Title - Sujet EGD South Jetty Reconstruction	
Solicitation No. - N° de l'invitation EZ899-172412/B	Amendment No. - N° modif. 010
Client Reference No. - N° de référence du client	Date 2017-07-24
GETS Reference No. - N° de référence de SEAG PW-\$PWY-026-8060	
File No. - N° de dossier PWY-6-39315 (026)	CCC No./N° CCC - FMS No./N° VME
Solicitation Closes - L'invitation prend fin at - à 02:00 PM on - le 2017-08-02	Time Zone Fuseau horaire Pacific Daylight Saving Time PDT
F.O.B. - F.A.B. Plant-Usine: <input type="checkbox"/> Destination: <input checked="" type="checkbox"/> Other-Autre: <input type="checkbox"/>	
Address Enquiries to: - Adresser toutes questions à: Yi (PWY), Patty	Buyer Id - Id de l'acheteur pwy026
Telephone No. - N° de téléphone (778) 919-2578 ()	FAX No. - N° de FAX (604) 775-6633
Destination - of Goods, Services, and Construction: Destination - des biens, services et construction: PWGSC - South Jetty Reconstruction Esquimalt Graving Dock (EGD), Victoria, BC

Amendment No. 010 is raised to incorporate the following:

AMENDMENT 010

ADDENDUM No. 004

Project No./No. de projet	
R.026723.002	
Sheet/Feuille	
S44-B	
Total Sheets/Total Feuilles	
0

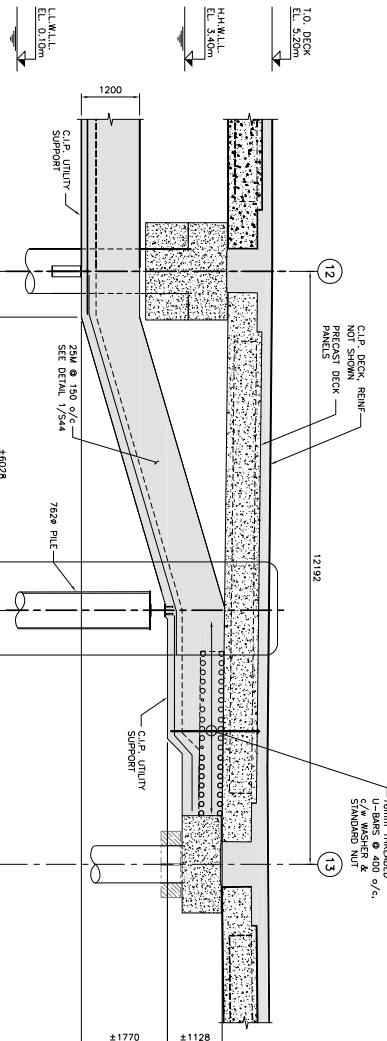
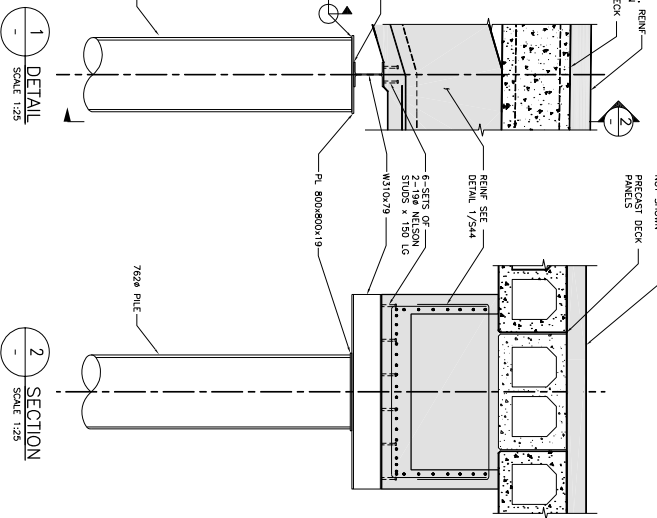
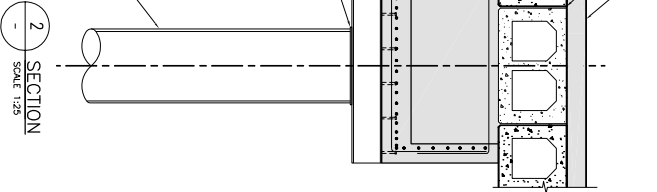
Page S44 rev3, what happens to the CIP utility support on the East side of bent 12?

Page S44-A, do we cast block outs in the box girder for the 16mm U-Bars and if so where?

Would you consider making this revision a provisional sum given the lack of details provided?

Same as west side but dimensions vary – see drawing S44B, issued with this amendment.

Sufficient details for tender provided with addition of drawing S44B.

1. ADD drawing S44-B Rev 0.
